Aerospace Report No.
ATR-77(7523-20)-6

EVALUATIONS OF
10 MW PILOT PLANT
DESIGNS

1 July 1977

Prepared by
THE AEROSPACE CORPORATION
Energy Systems Group
El Segundo, California 90245

FIGURE I - FOCUS OF BOEING HELIOSTATS VS. RANGE AND SEASON (750 psi membrane tension)

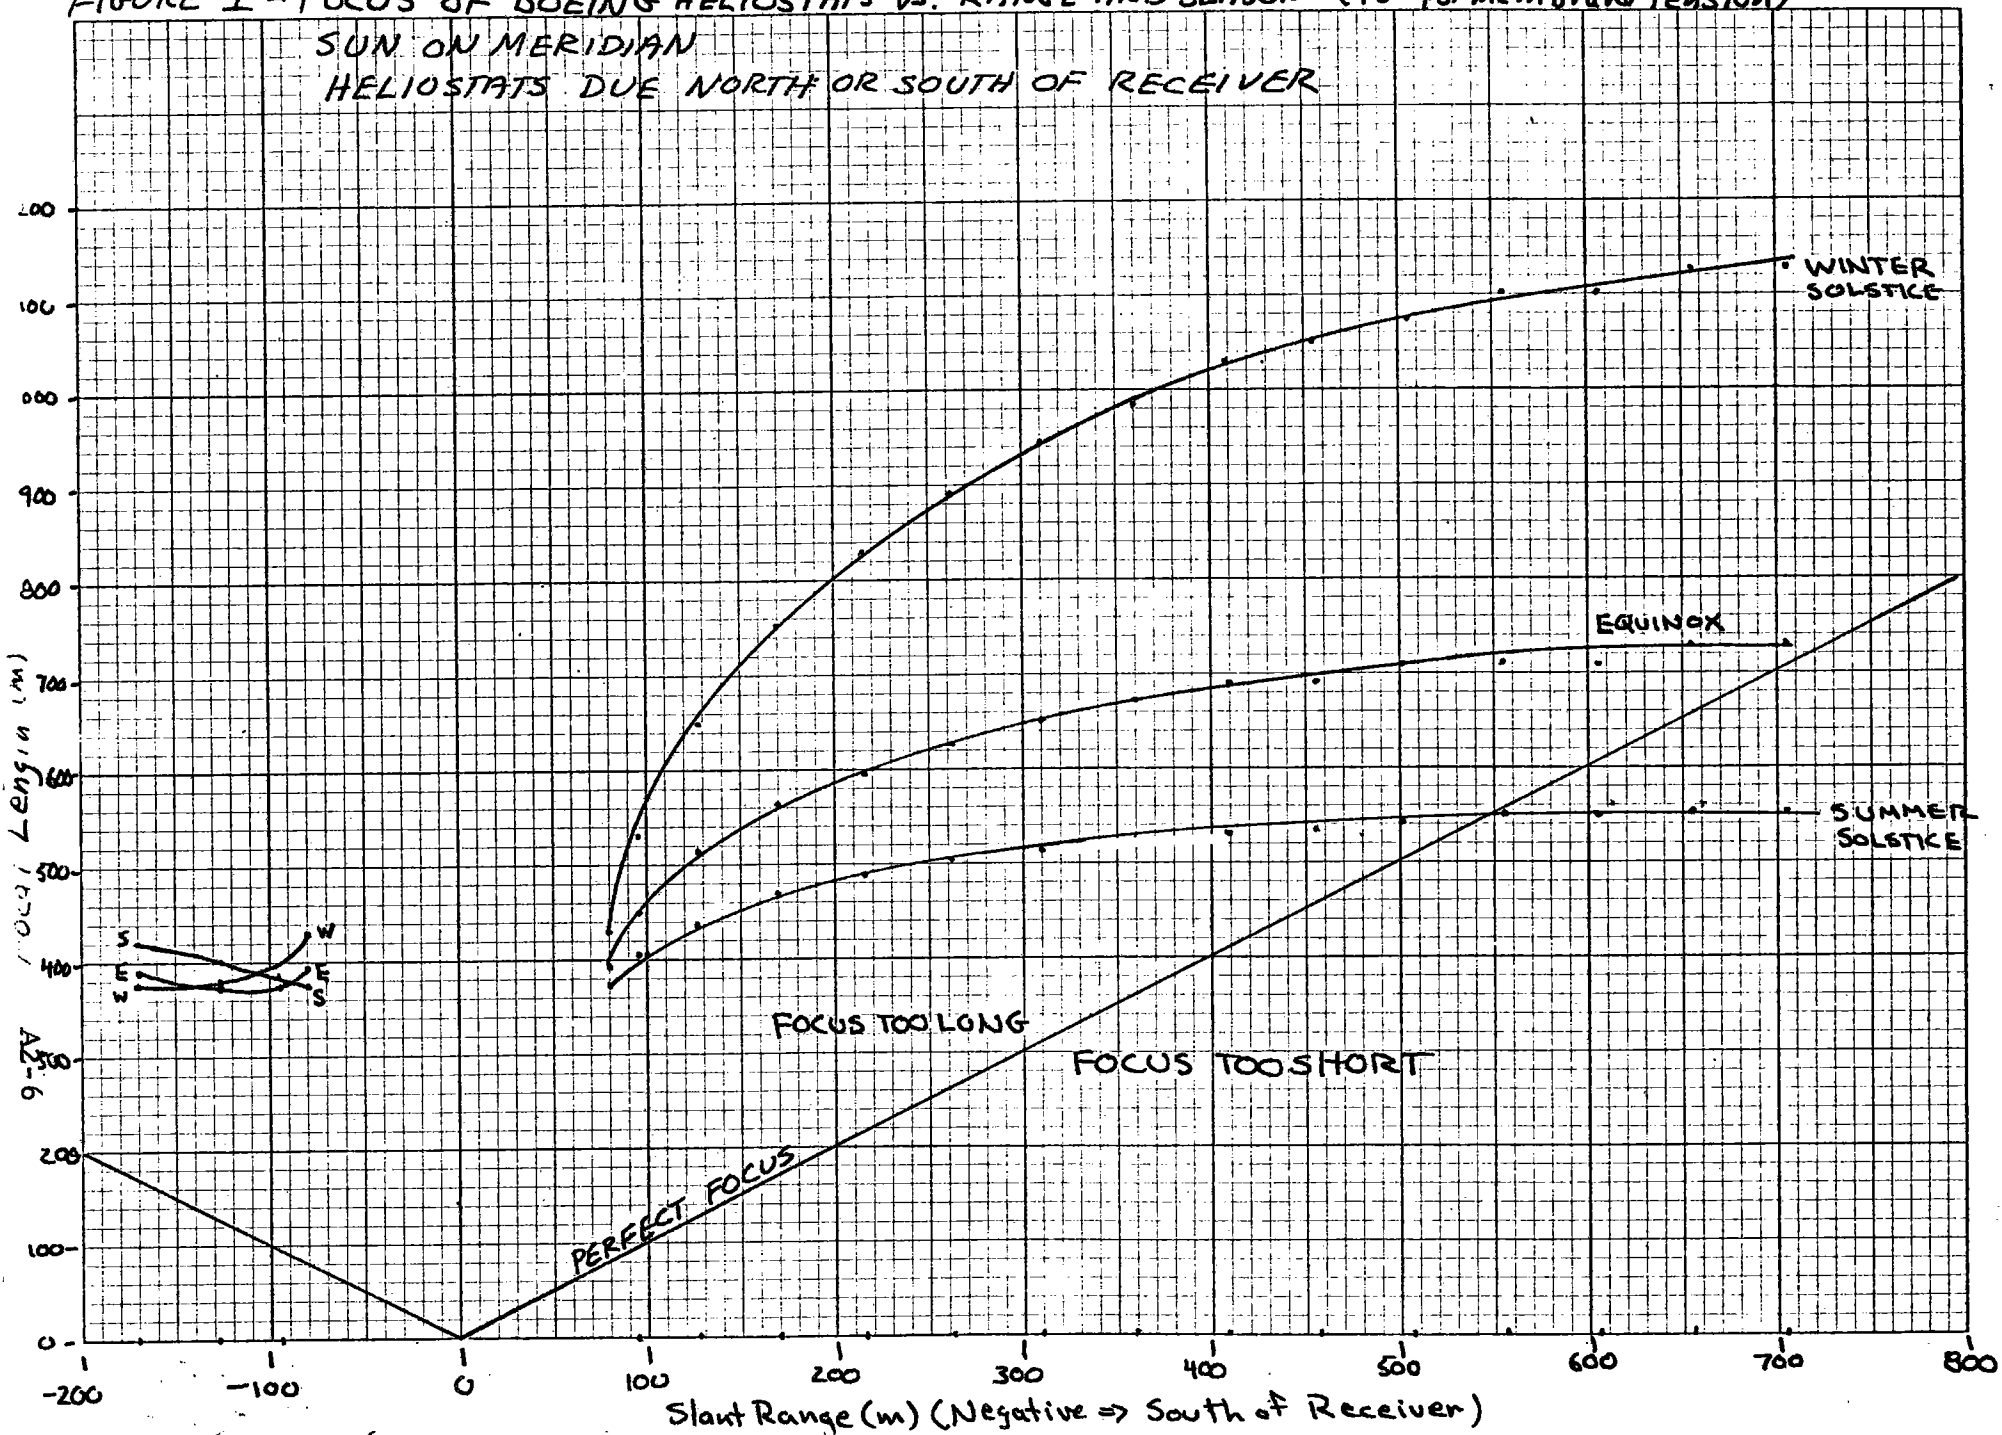
The gravity focusing inherent in the stretched membrane design has the advantage of being partially compensating for heliostat range. For a given sun altitude, more distant heliostats tend to have their surfaces more nearly vertical, resulting automatically in a longer focal length. That the compensation is only partial is shown in Figure I, where focal length is plotted against range for heliostats, receiver and sun, all in a N-S plane. The heliostats are seen to focus long except for the extremities of the Martin field in summer. It appears (see Appendix A-1) that if a constant focal length is to be used throughout the field, it should be picked to be somewhat less than the maximum slant range. This implies that the membrane tension

(focal length) should be decreased somewhat from the 750 psi used to generate Figure I, provided surface quality could be maintained. W. Delameter (Sandia) has pointed out that the membrane tension will decrease with increasing temperature. Since the temperature inside the bubbles is likely to be higher than that outside due to greenhouse effect, the membrane tension should be set sufficiently high so that surface quality does not deteriorate at the highest operating temperature.

Figure 1 : Subsystem Redundancy

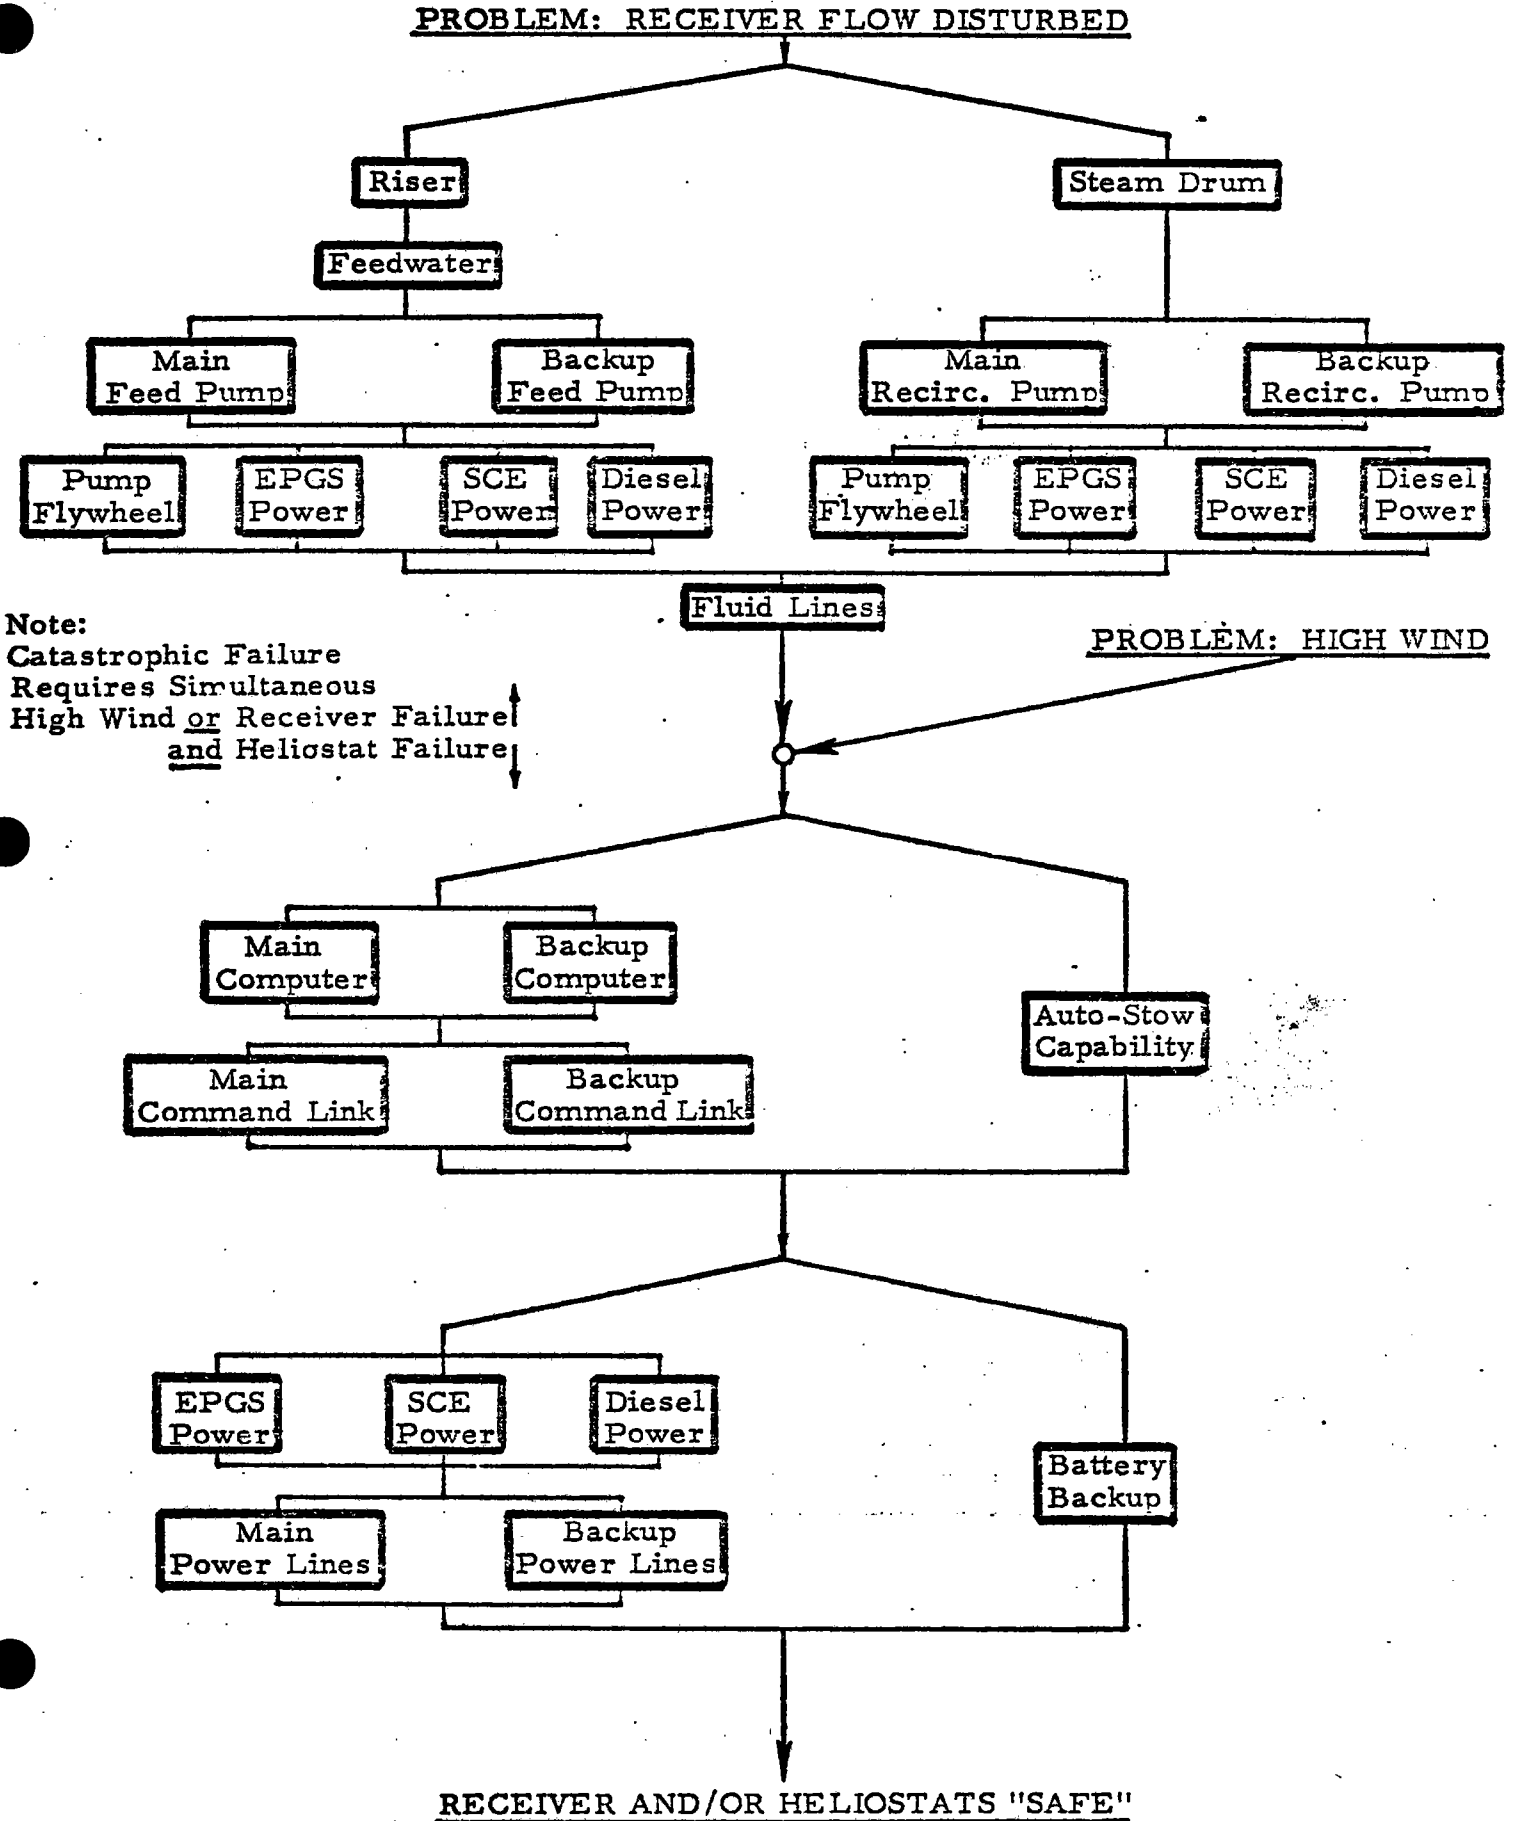
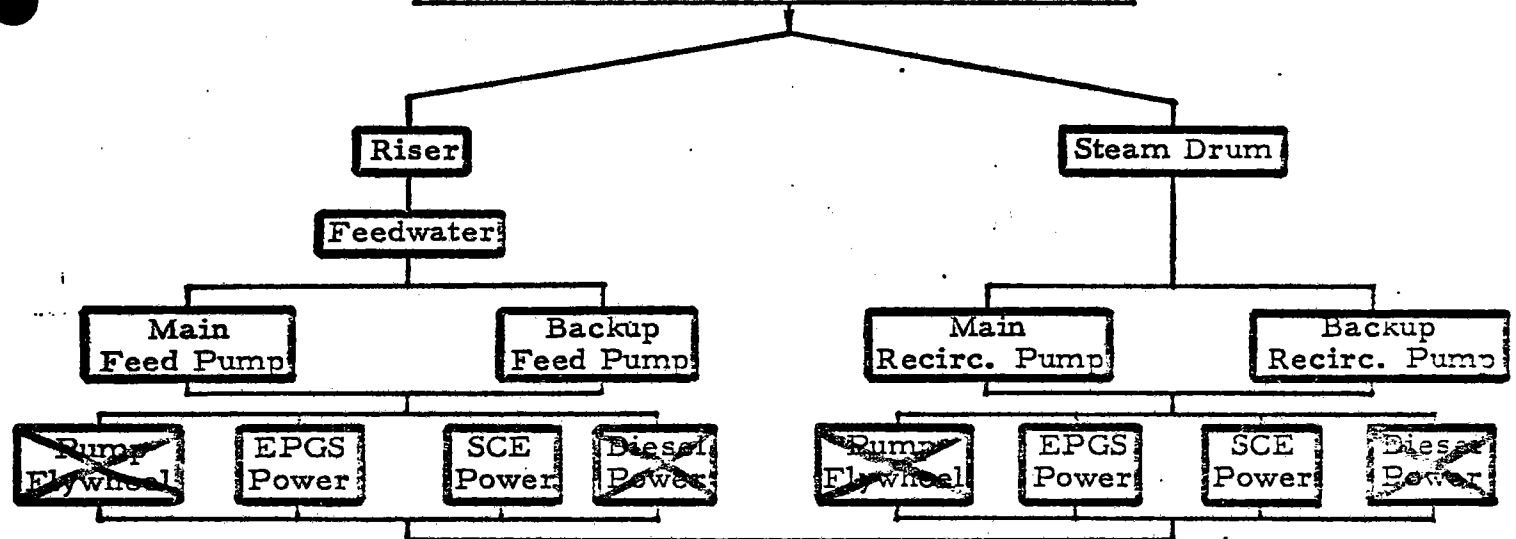
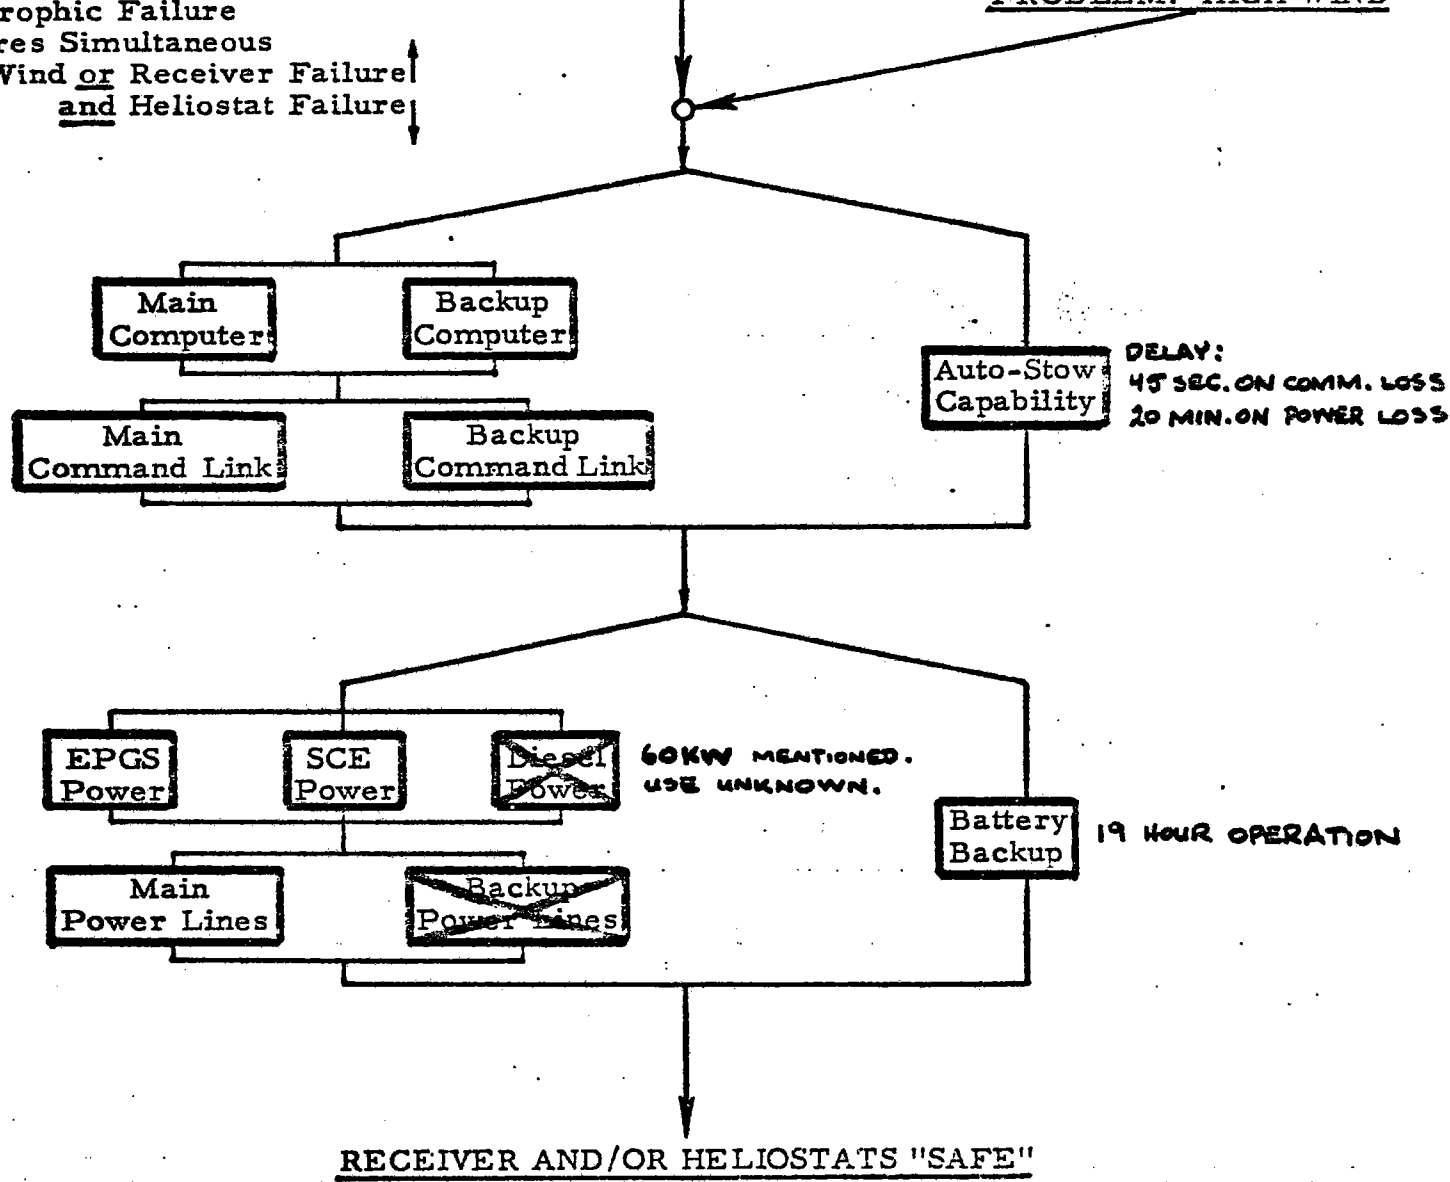
A set of charts are attached, illustrating the redundancy provided by each contractor's receiver and heliostat designs. Figure 1 is an unaltered version. Figures 2 - 4 are marked up to reflect the Honeywell, MMC and MDAC designs. Figures 5 - 7 are marked up to reflect the Boeing collector in combination with each of the 3 receivers.

Figure 9 illustrates the suggested degree of redundancy which is thought to be desirable. In the receiver, some type of steam drum or water reservoir should back up the riser loop. Recirculation pumps are not advisable because of their added cost and complexity, and because receiver flow then becomes dependent of the power lines up the tower. Diesel backup or flywheels on the feedwater pumps are not recommended because they provide an excessive amount of redundancy.

Figure 1: Critical Problems & Their Consequences

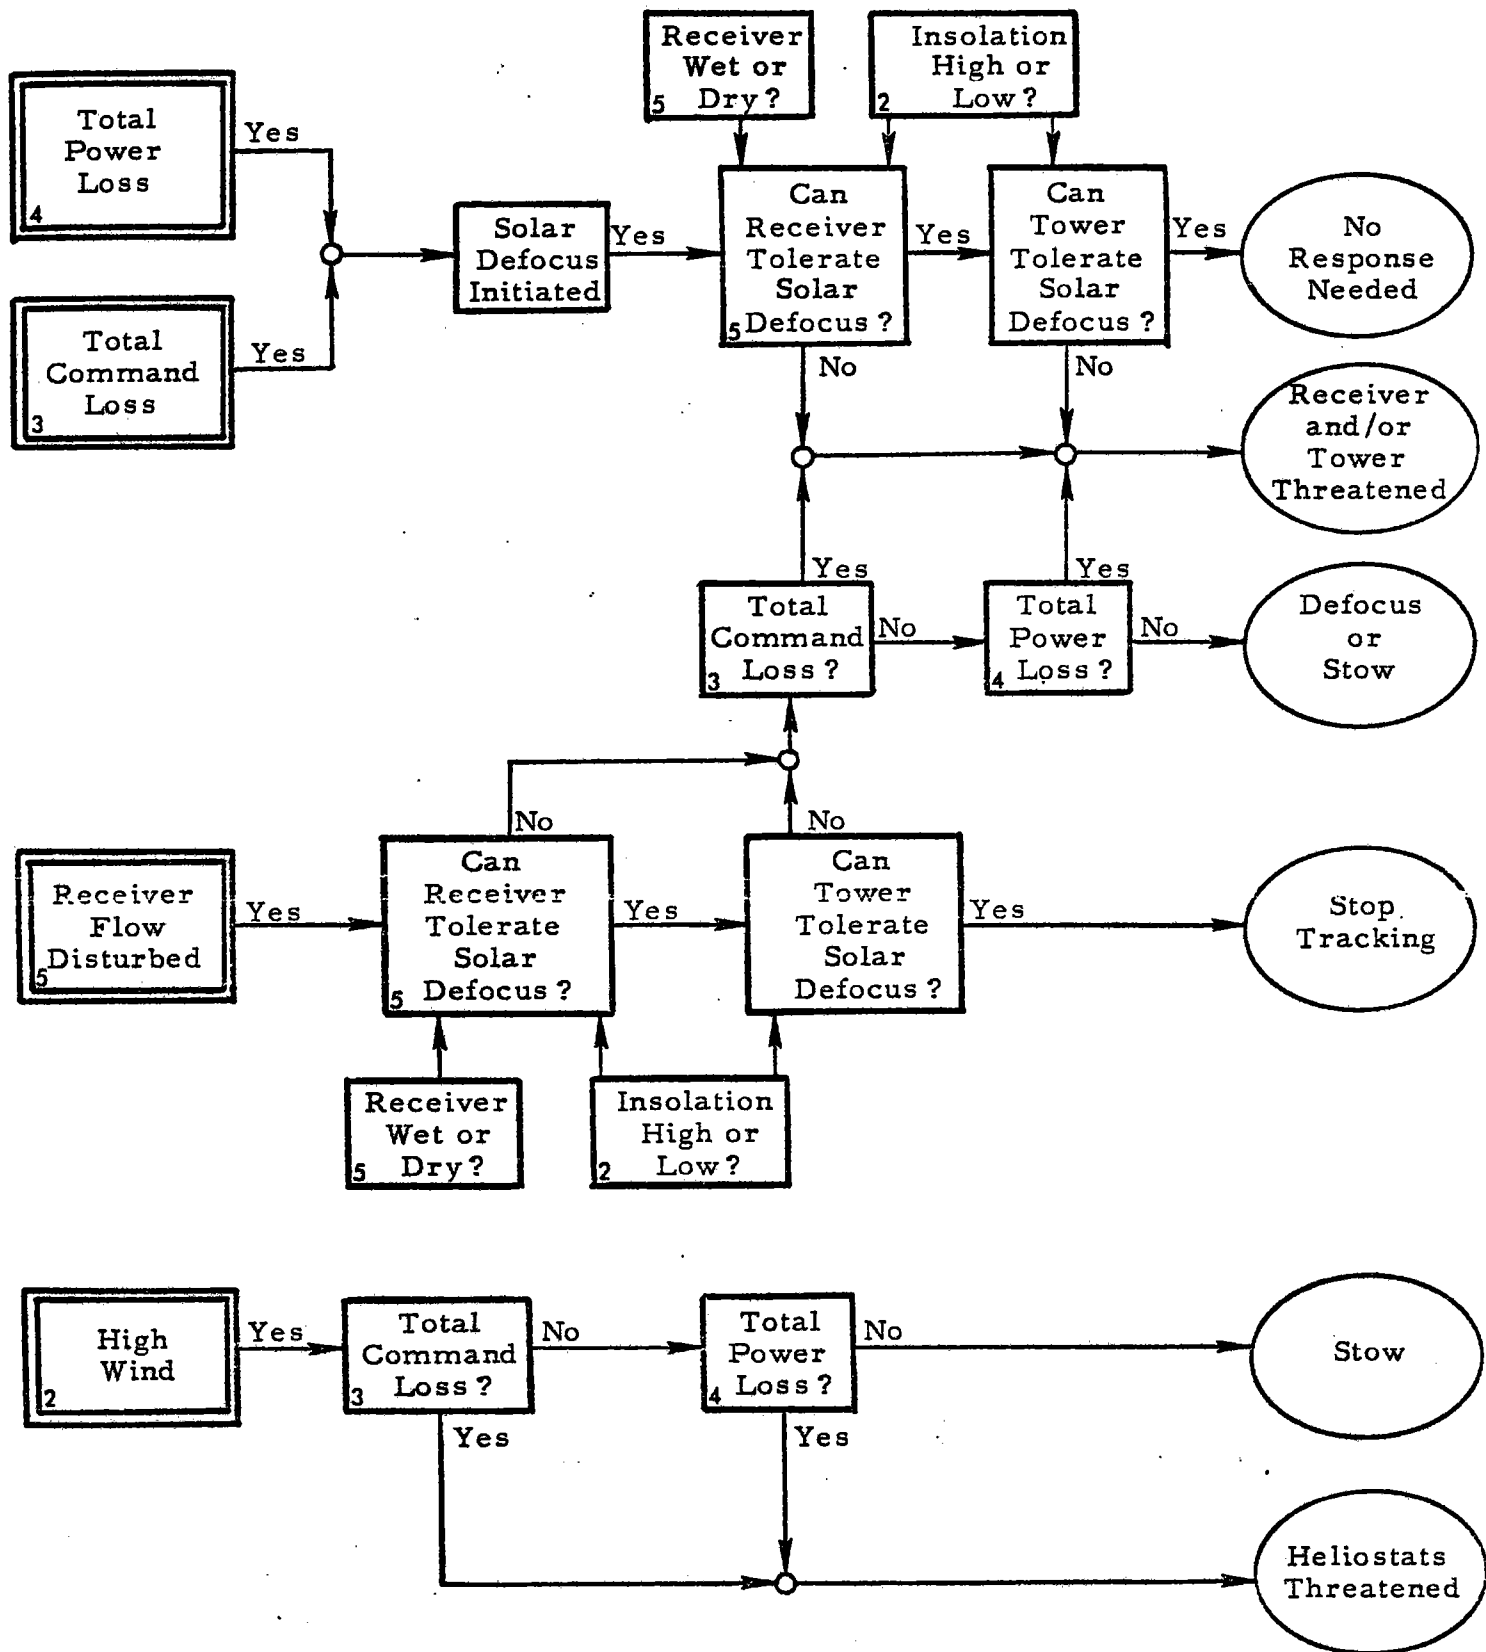
Given one of these problems, Figure 1 is entered at the left. The problem leads to a series of questions related to other subsystems. The answers to these questions dictate the path through the logic chain, leading ultimately to one of the consequences or actions arrayed on the right.

Figure 1 illustrates the interdependence of the heliostats and the receiver/tower. In particular, it demonstrates that the receiver/tower can be decoupled from the heliostats if both the receiver and tower can tolerate solar defocusing of the heliostats. The tolerance of the tower (the structure around the receiver cavity) is dictated by design and cannot be controlled. The tolerance of a dry receiver is also design dependent. However, since receiver flow is controllable, receiver tolerance can be insured if a minimal rate of water/steam flow can be maintained.

Two desirable design objectives follow from Figure 1. The tower should be designed to tolerate solar defocusing and; some flow redundancy should be provided the receiver. These 2 objectives, if met, would tend to isolate heliostat control failures from receiver failures and vice versa.
